**SUBJECT: PALO VERDE NUCLEAR GENERATING STATION, UNITS 1, 2, AND 3 –
STAFF ASSESSMENT OF RESPONSE TO 10 CFR 50.54(f) INFORMATION
REQUEST – FLOOD-CAUSING MECHANISM REEVALUATION (CAC NOS.
MF5546, MF5547 AND MF5548)**

STAFF ASSESSMENT BY THE OFFICE OF NUCLEAR REACTOR REGULATION

RELATED TO FLOODING HAZARD REEVALUATION REPORT

PALO VERDE NUCLEAR GENERATING STATION, UNITS 1, 2, AND 3

Figure 3.2-2. Flow Path Locations for Unit 1. Locations for Units 2 and 3 are similar.

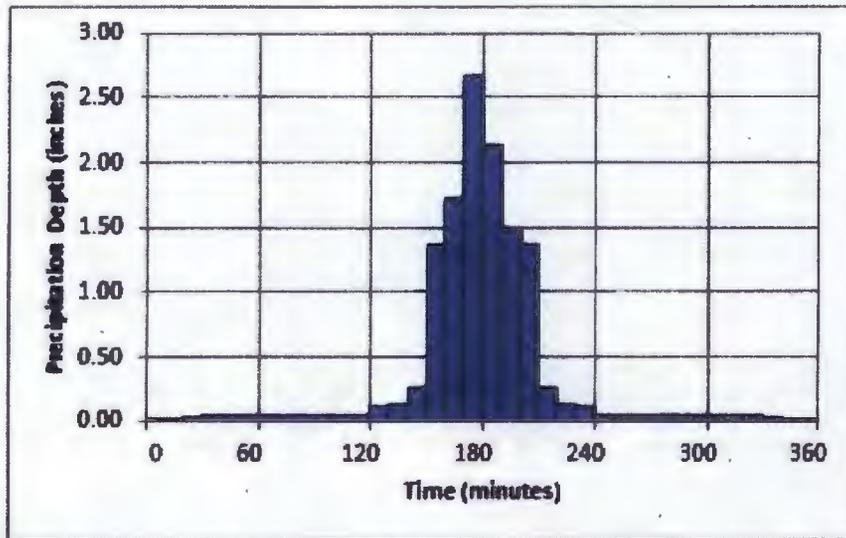
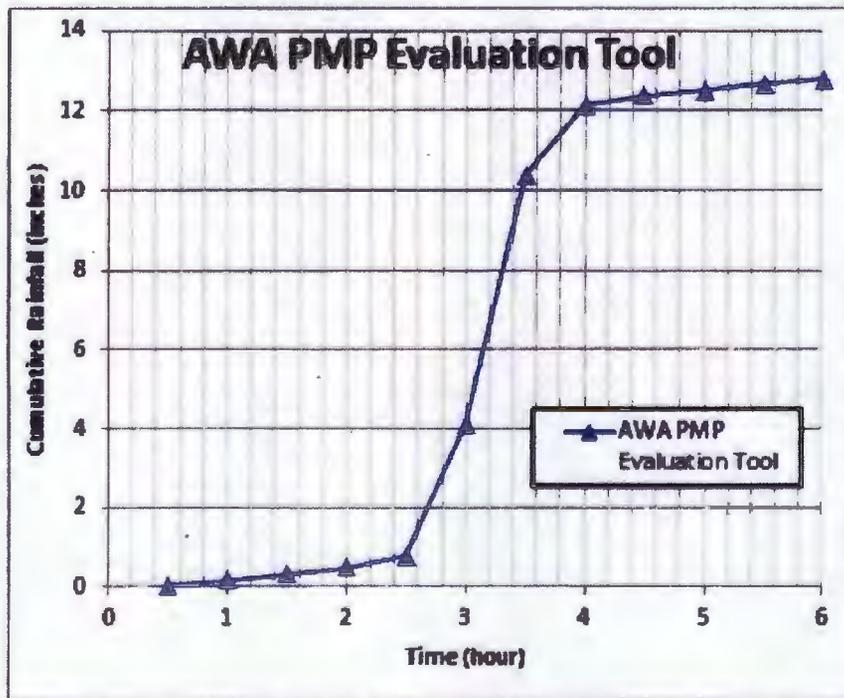
In evaluating the site drainage resulting from the LIP event, the licensee evaluated flood stages at 55 flow path locations common to each reactor unit (NRC, 2016b; see Figure 3.2-2) and reported the maximum estimated flood elevation corresponding to each location for each reactor unit (i.e., a total of 115 locations). Because of local topographic variations at each of the three units as built, local maxima of inundation depths were reported at different flow path locations for each of the three reactors.

The licensee identified 55 potential flow path locations around each reactor unit by which flood water could potentially affect plant safety, and reported maximum flood elevation, maximum flood depth, flooding duration, maximum velocity, and maximum hydrostatic and hydrodynamic forces (NRC, 2016b). Flow path locations for Unit 1 are shown in Figure 3.2-2 using that reactor's layout as an example. The licensee stated that two of the pathways at each reactor unit location were excluded as special cases, specifically a low-grade area in the North Yard

The staff verified the results reported in the FHRR using the computer input files provided by the licensee. The staff reviewed the resulting model output and determined that (a) mass balance errors were small, (b) flow pathways and areas of inundation appeared reasonable, and (c) flow velocities were reasonable with no indication of numerical instabilities and no unexpected supercritical flow conditions were identified near potential flooding pathways. Based on these results, the staff finds the licensee's FLO-2D model to be an appropriate basis for evaluating water elevations from LIP and associated site drainage.

Using results from the FLO-2D computer model, the staff determined that maximum flood depth above the inlet height of each potential flooding pathway varied across the site, with maximum depths of 0.6 ft (0.2 m), 0.6 ft (0.2 m), and 0.34 ft (0.1 m), respectively, at Units 1, 2, and 3. The reported WSEs and flood water depths for each reactor unit and flow path location are shown in Table 3.2-1. The staff determined that flood depth exceeded the inlet heights at about half the potential flooding pathways. The staff confirmed that flood depths were greater than 0.6 ft (0.2 m) for some of the excluded pathways identified by the licensee. Flood depths along the breezeway between the Unit 2 Auxiliary and Turbine Buildings were about 0.8 ft (0.2 m) higher than the corresponding areas for Units 1 and 3. Based on a review of the topographic data and the model grid cell elevations (described above), the staff determined that the FLO-2D model results for the Case 4 simulation overestimated the flood depths along the Unit 2 breezeway and underestimated the flood depths at some potential flooding pathway locations of Unit 3. The staff reviewed the simulated flow paths around the three reactor units and determined that flooding around the safety-related structures of each unit is substantially independent of flow conditions at the other units. Given the similarity in site layout of the three units, the staff concluded that flood depth along the breezeways for Unit 2 and Unit 3 was best represented by the Case 4 simulation results. The staff further concluded that the licensee's estimate of maximum flood depth above the inlet height of 0.6 ft (0.2m) is appropriate for each of the three reactor units.

Using the results from the Case 4 LIP simulation, the staff evaluated the maximum water-surface elevation at each unit for the non-excluded, potential flooding pathways identified by the licensee. The staff confirmed the licensee's maximum WSEs reported in the FHRR of 957.7 ft (291.9 m), 955.0 ft (291.1 m), and 952.4 ft (290.3 m) NGVD29, respectively, for Units 1, 2, and 3.
